Presentation to the ACRS Subcommittee

Vogtle Early Site Permit Review Status

Section 2.5 Geology, Seismology and Geotechnical Engineering

October 24, 2007

The Pen Branch Fault extends beneath the ESP site based on subsurface geophysical data

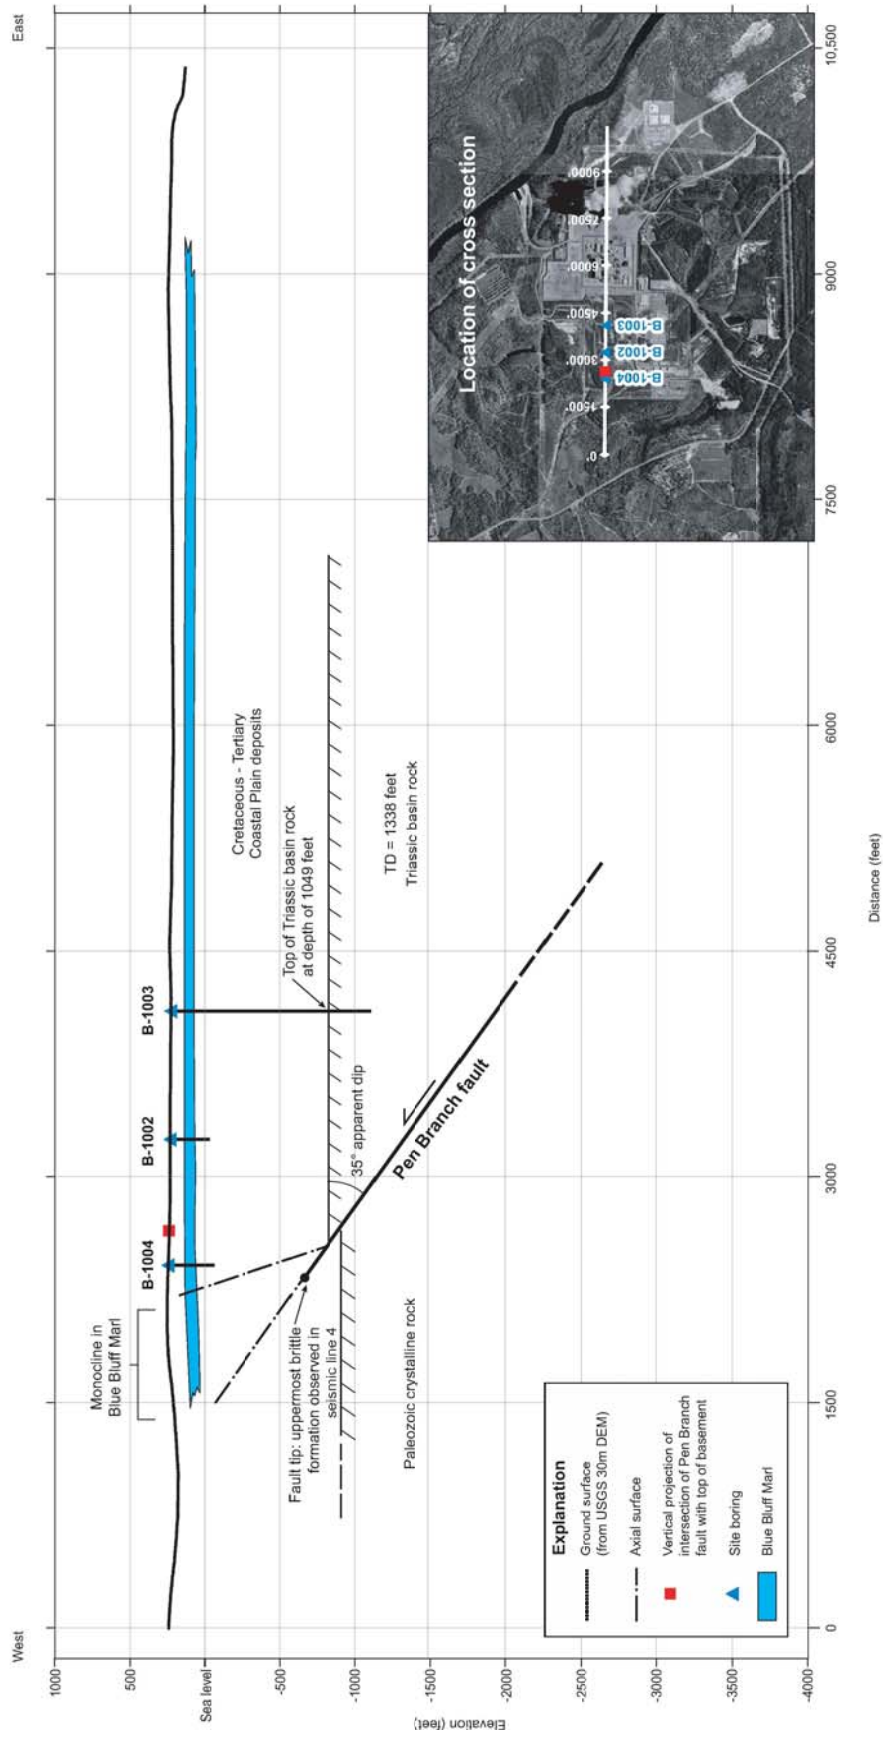
- **Pen Branch Fault**
 - ~25 mi. total length, strikes N46-66E, dips 60-75SE
 - Exhibits no expression of surface displacement
 - Exhibits no seismic activity

Quaternary Terrace Surface Overlying the Pen Branch Fault at the SRS

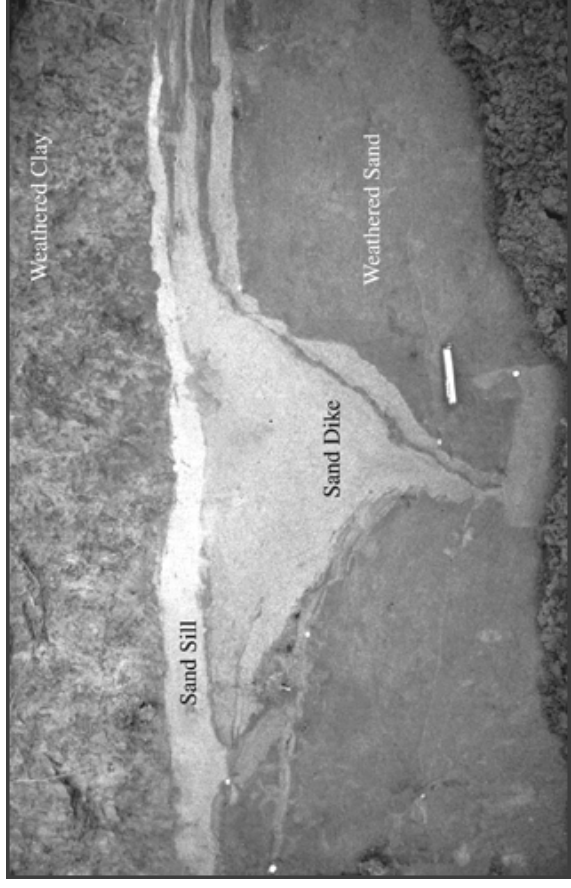
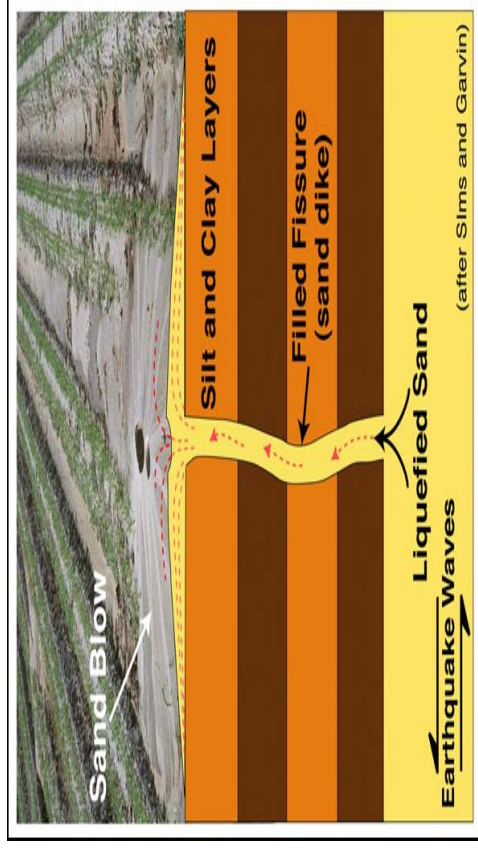
- No stratigraphic evidence of fault movement < 33.7 my old (post-Eocene)
- Applicant evaluated Savannah River terraces for evidence of local fault displacement during the past 1.8 my (Quaternary)
 - Field evidence indicates that the Pen Branch is not a capable fault

Updated Charleston Seismic Source

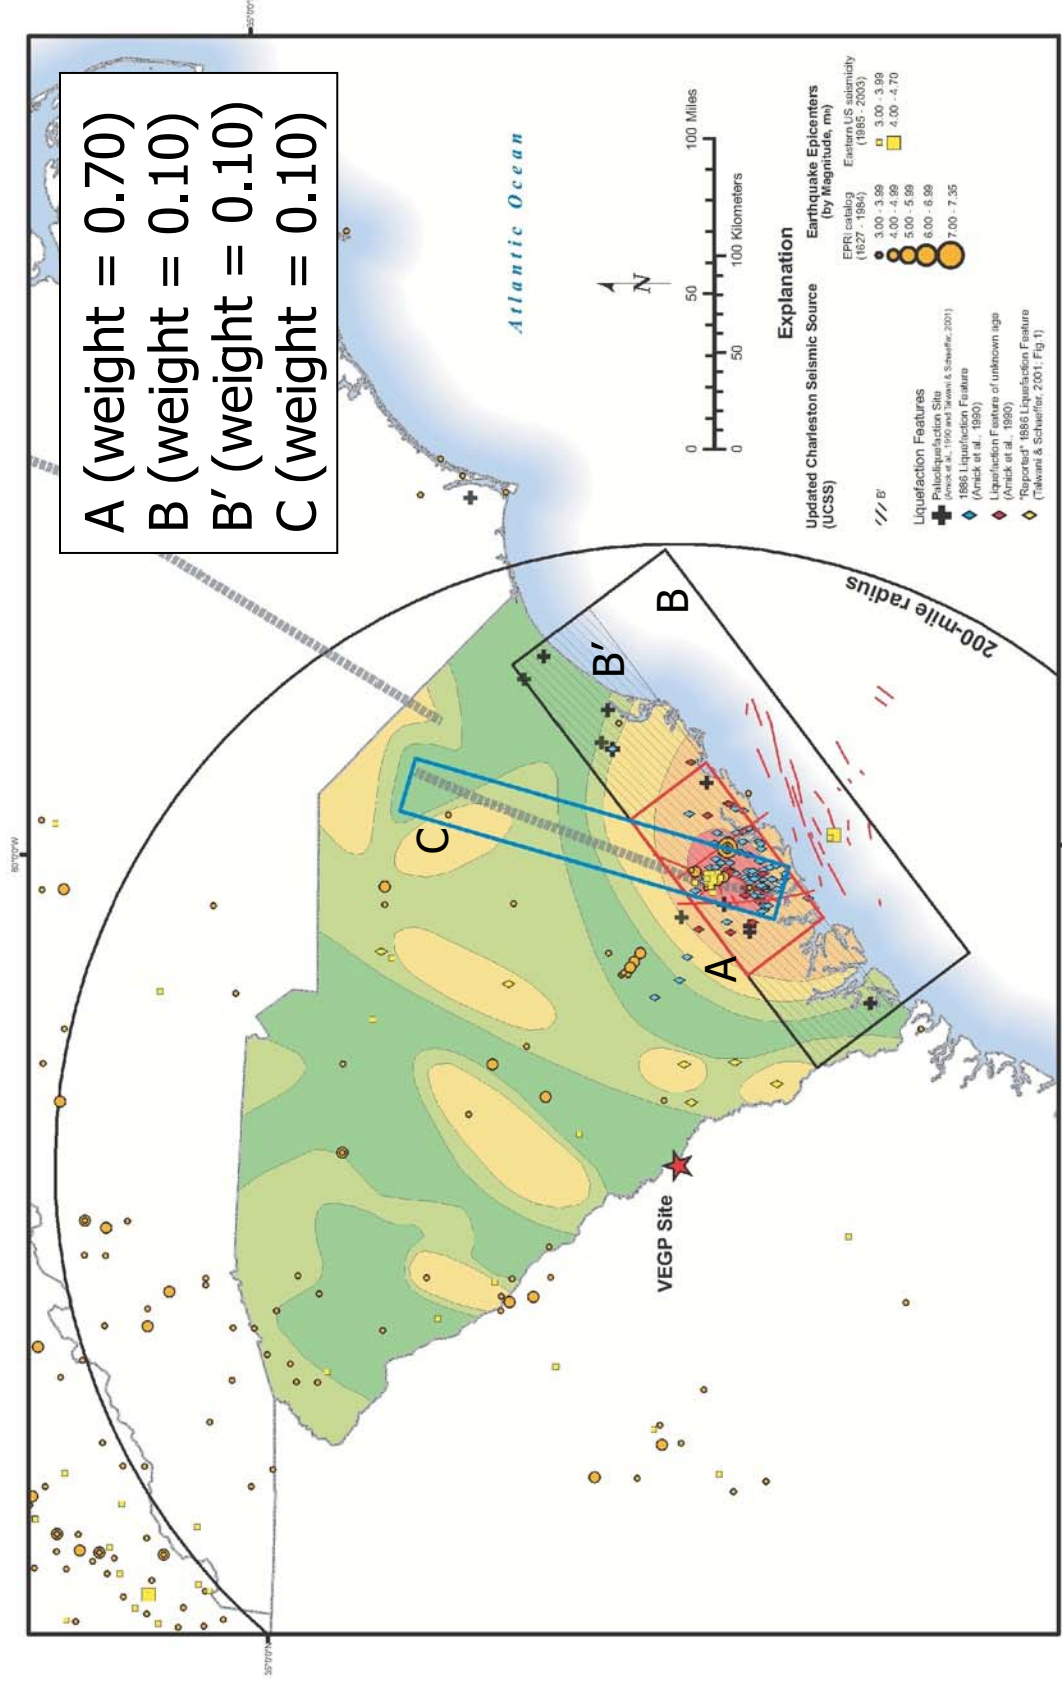
- NRC Staff concluded that the applicant did not provide sufficient paleoliquefaction evidence to rule out the occurrence of large inland earthquakes (OI 2.5-5)
- The occurrence of a large earthquake, inland from the coast, may necessitate a different Charleston source zone model

10-Hz Total Mean Hazard Curve

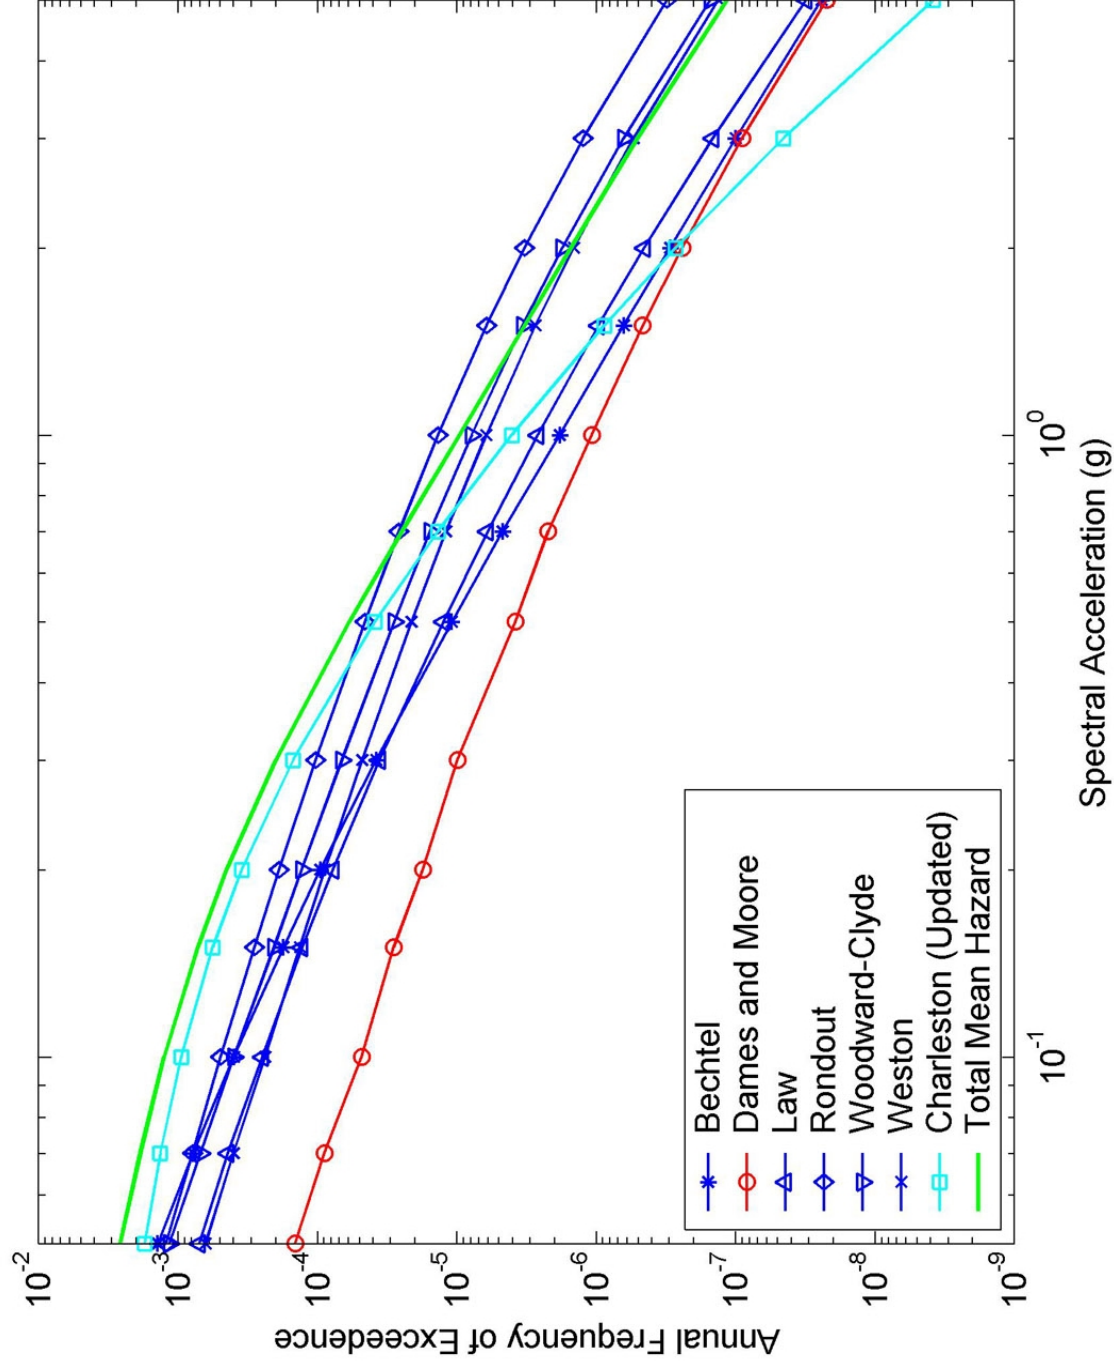
- **Regional Seismic Source Zone $M_{\max}$ and Probability of Activity (OI 2.5-1)**
 - EPRI seismic source zones were determined by six Earth Science Teams during the 1980s
 - Dames and Moore team assigned low weights for larger $M_{\max}$ values (and low probabilities of activity) to two of their regional source zones
 - Resulting Dames and Moore hazard curves for the ESP site do not adequately characterize the regional hazard
